**TOWN OF MOUNTAIN VILLAGE  
REGULAR DESIGN REVIEW BOARD MEETING AGENDA  
THURSDAY NOVEMBER 7, 2024, 10:00 AM  
MOUNTAIN VILLAGE TOWN HALL  
455 MOUNTAIN VILLAGE BLVD, MOUNTAIN VILLAGE, COLORADO  
TO BE HELD HYBRID THROUGH ZOOM:  
<https://us06web.zoom.us/j/89842973313>  
Meeting ID: 898 4297 3313**

**TO:** Mountain Village Design Review Board  
**FROM:** Claire Perez, Planner II  
**FOR:** Design Review Board Public Hearing; November 7, 2024  
**DATE:** October 23, 2024  
**RE:** Staff Memo – Final Architecture Review (FAR) for Lot 649R unit 10, TBD Boulders Way.

**TO:** Mountain Village Design Review Board  
**FROM:** Drew Nelson, Senior Planner  
**FOR:** Design Review Board Public Hearing; November 7, 2024  
**DATE:** October 30, 2024  
**RE:** Staff Memo – Initial Architecture and Site Review (IASR) Lot 165 Unit 17R, TBD Cortina Drive, pursuant to the CDC

C2

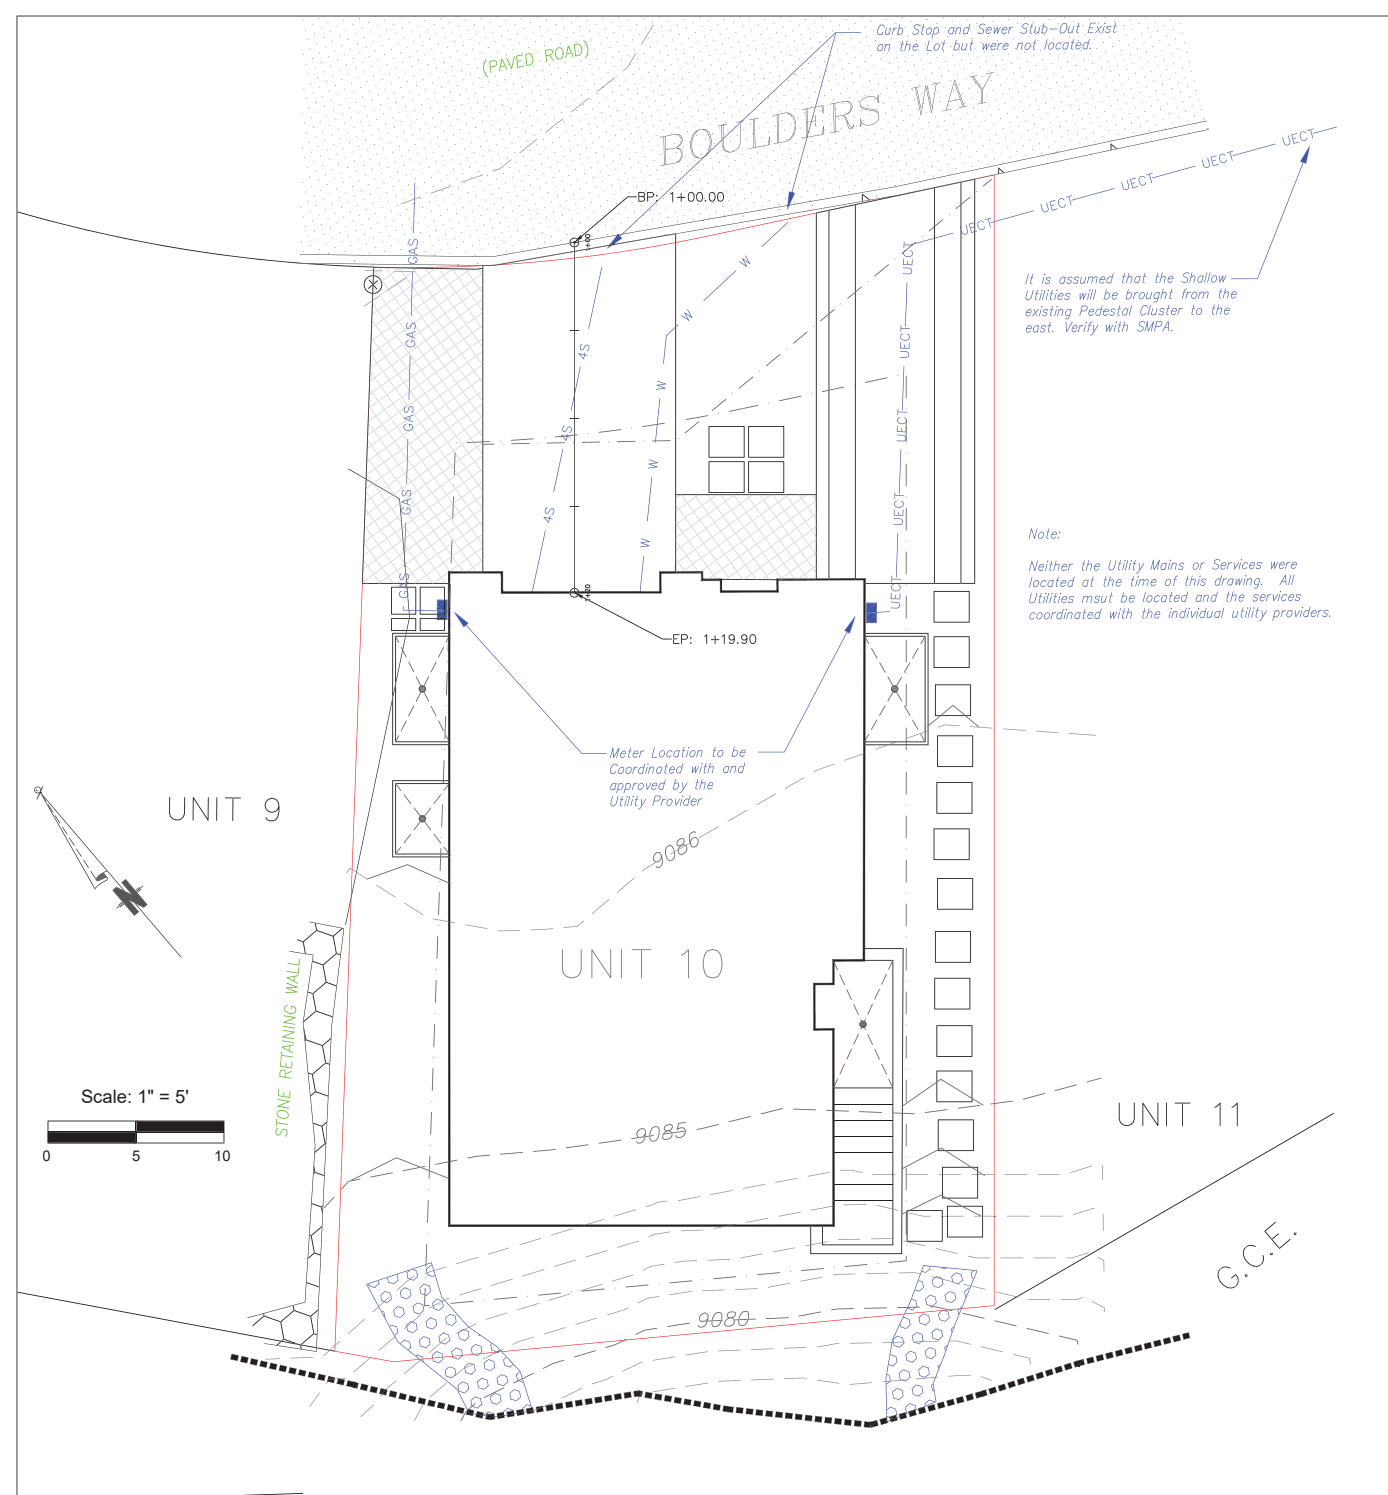
*Staff: The applicant provided a utility plan on Sheet C2. The plan shows the sewer and water lines crossing the front setback to connect in Boulders Way. The electric and gas lines will cross the side setback to connect to an existing Pedestal to the east. Staff sees no issues with this plan. The applicant will need to field verify the proposed locations.*

- 4) Prior to the issuance of a building permit, the applicant shall field verify all utility locations.
- 5) Consistent with town building codes, Unenclosed accessory structures attached to buildings with habitable spaces and projections, such as decks, shall be constructed as either non-combustible, heavy timber or exterior grade ignition resistant materials such as those listed as WUIC (Wildland Urban Interface Code) approved products.

**1 CONSTRUCTION MITIGATION PLAN**  
 1/8" = 1'-0"

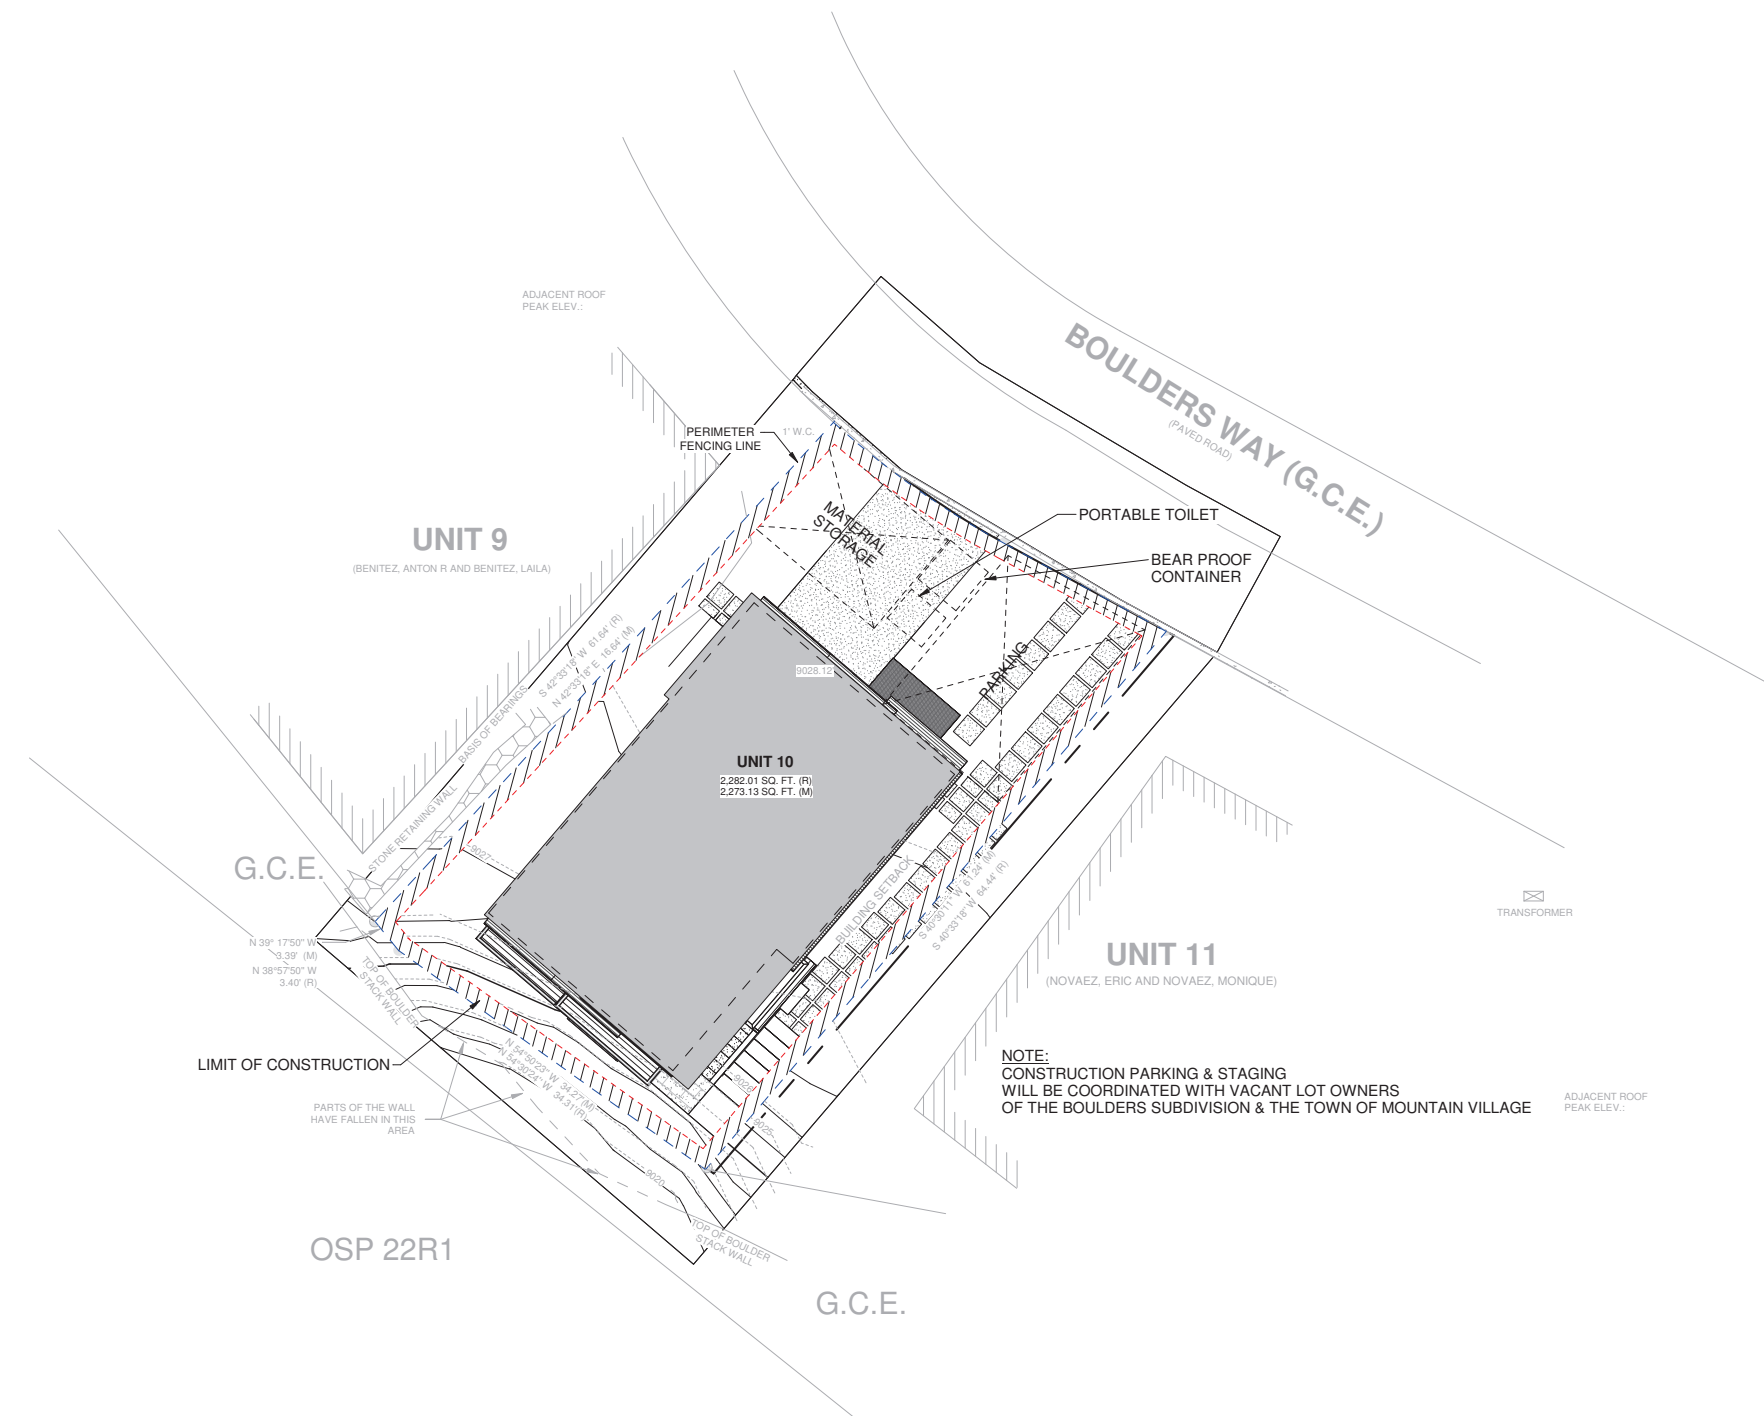
*Staff: The construction mitigation plan shows required material staging, dumpster, bear-proof trash receptacles, and a port a toilet. The plan should be revised to include silt fencing or storm water management devices on the downhill side of the lot. There is only one parking space indicated on the plan. The construction mitigation plan narrative notes that parking and material staging will be on Units 2 and 17 as allowed. Overflow parking will be at the Big Billie's parking lot. The applicant will need to provide authorization for the use of the lots and coordinate parking in the Big Billie's lots with the Town.*

- 1) Prior to building permit, the applicant shall revise the construction mitigation plan to include storm water management devices on the downhill slope

**1 ARCHITECTURAL SITE PLAN**  
 1/4" = 1'-0"

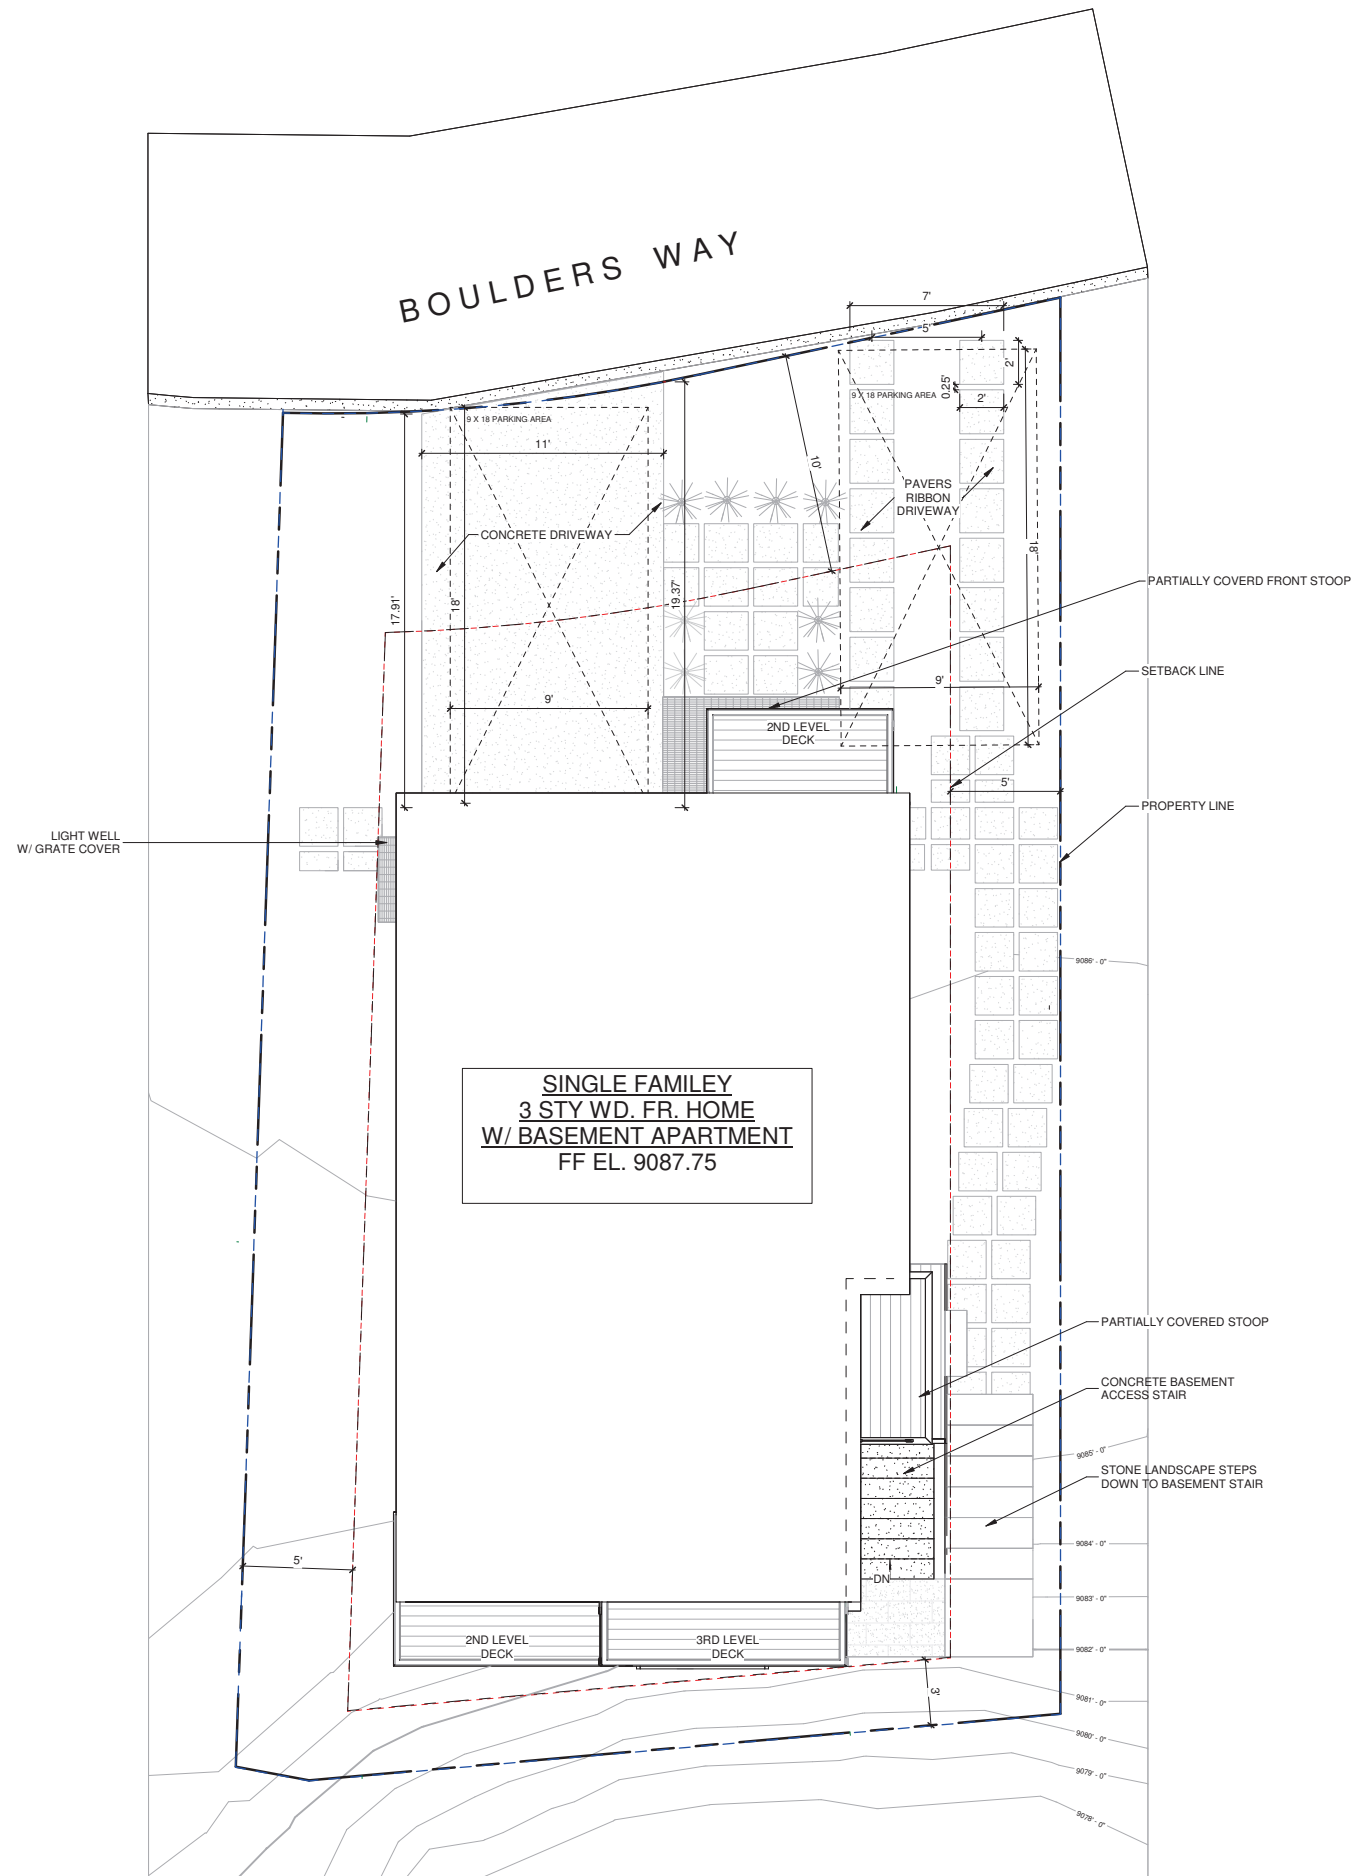
*Staff: The applicant has shown one interior parking space and two exterior spaces on their architectural site plan. The exterior parking spaces are separated by landscape steppingstones in the center. The parking configuration as shown will require DRB specific approval of tandem parking. Due to the limited size of the lot, the applicant has proposed a portion of the exterior spaces within the front and side setback. The eastern parking space is proposed as a paver ribbon style driveway. The setback encroachments require specific approval from the DRB.*

*Staff: The applicant has proposed a section of concrete driveway, with pavers to the left of the driveway. The width of the concrete driveway is shown at 17.91'x11'. The minimum width required by the CDC is 12. The width should be revised prior to building permit CDC requirements.*

- 2) Prior to building permit, the applicant shall revise the width of the driveway to meet CDC requirements.
- 3) Prior to the issuance of a building permit, the landscape plan shall be amended per the Town Forester's comments.

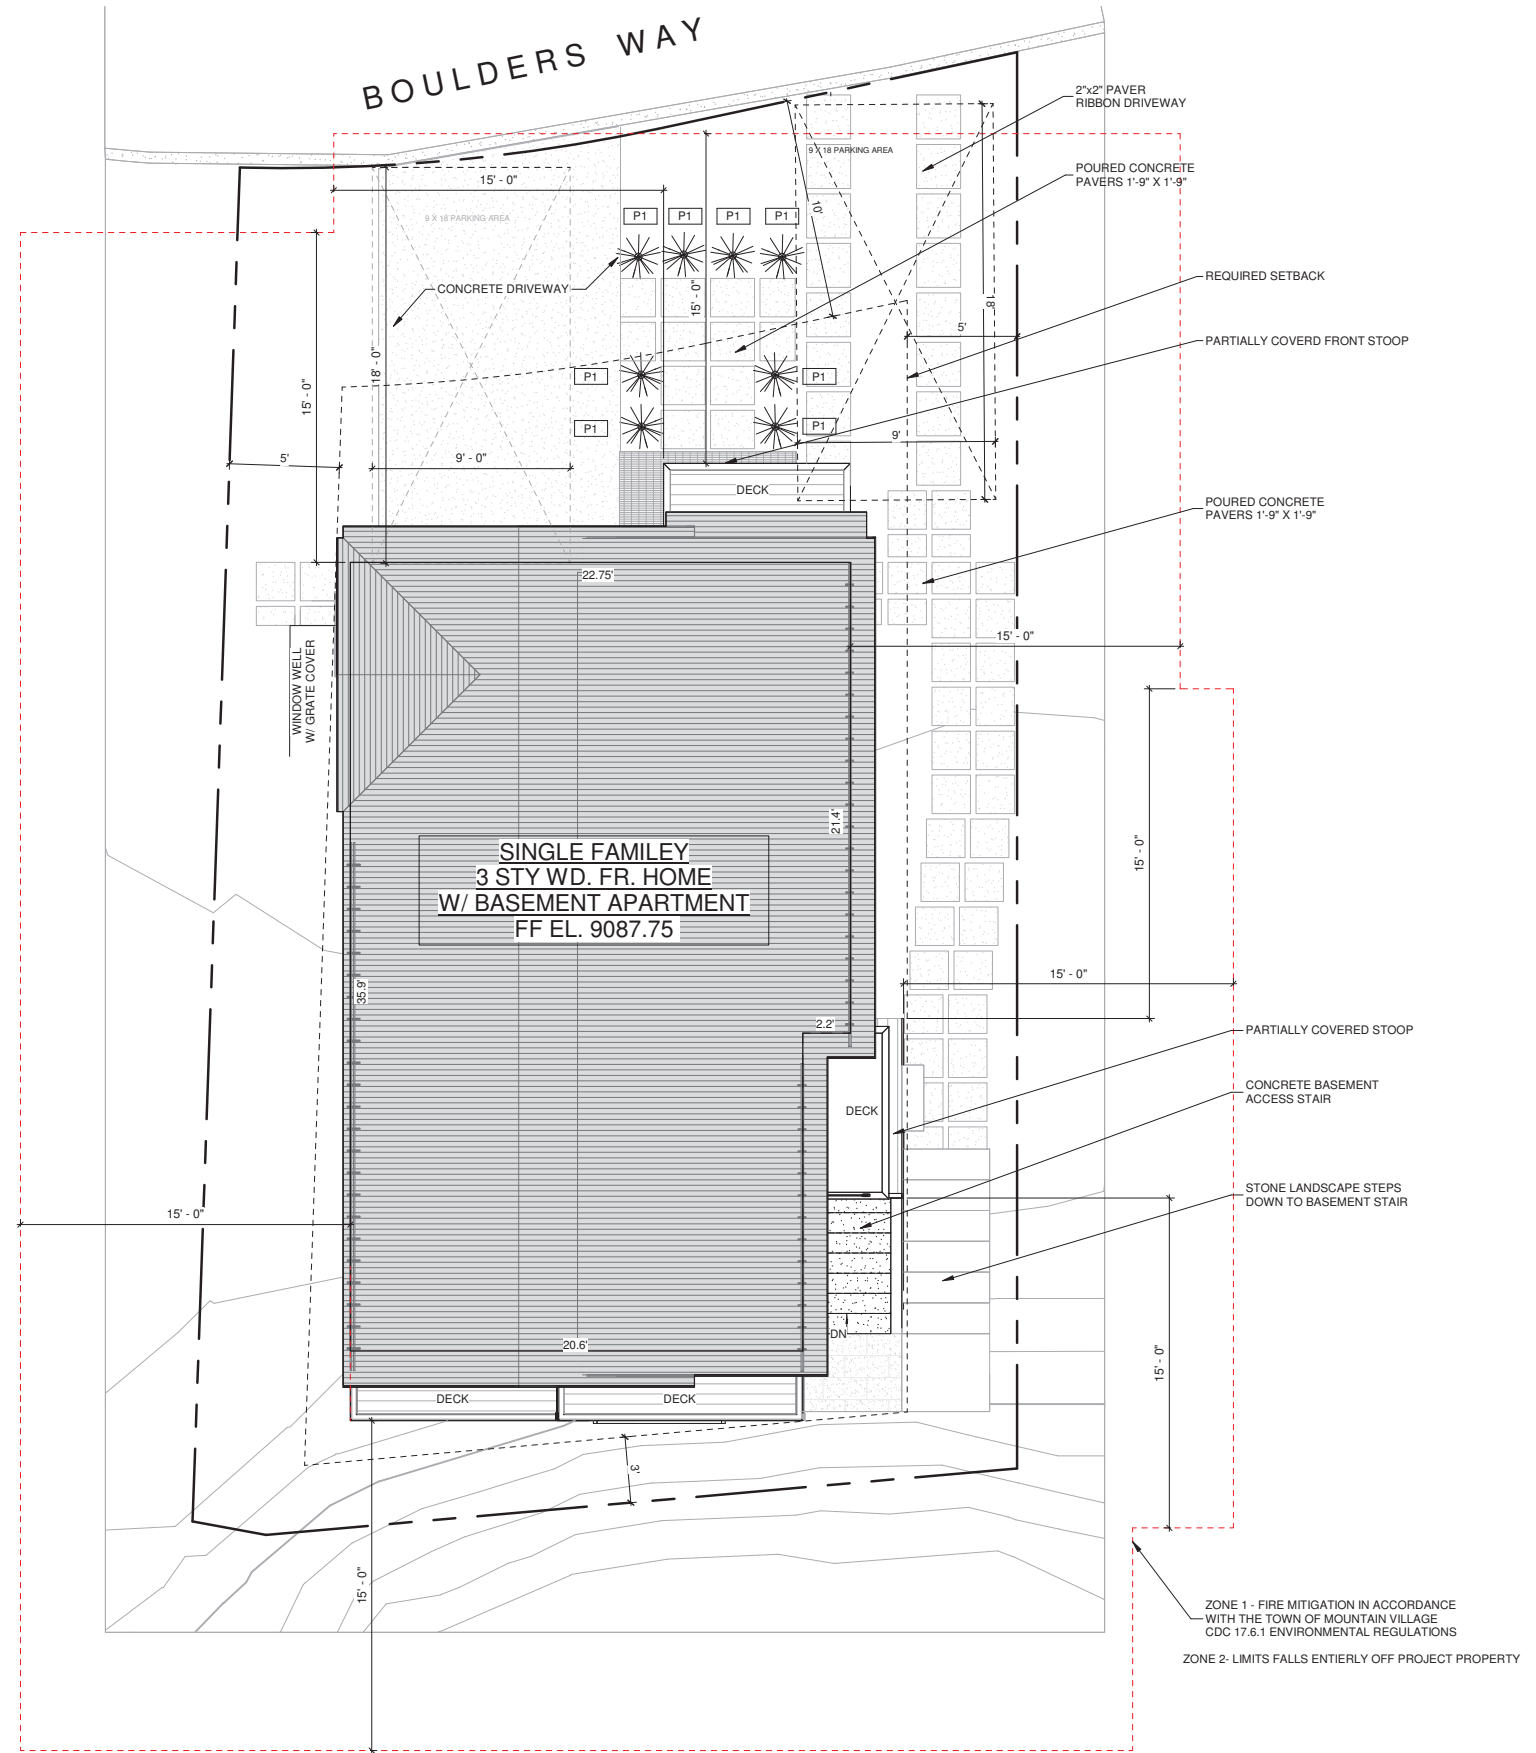
*Staff: The applicant has provided a landscape plan on Sheet A1.2. There is no existing vegetation on site. The applicant has proposed 8 Woods Rose bushes on the site. The landscaping plan needs to be revised to include a tree planting detail that shows the proper steps required in planting trees and shrubs.*

*The plan also needs a note that states that the burlap and wire basket must be removed to at least the top 12 -16 inches of the root ball. The plan should be amended per the Forester's comments prior to building permit.*

*Staff: Fire Mitigation and Forestry Management: A fire mitigation plan was provided on Sheet A1.2. Due to the small lot size, Zone 1 fire mitigation encompasses the entire lot. The fire mitigation plan adheres to CDC requirements.*
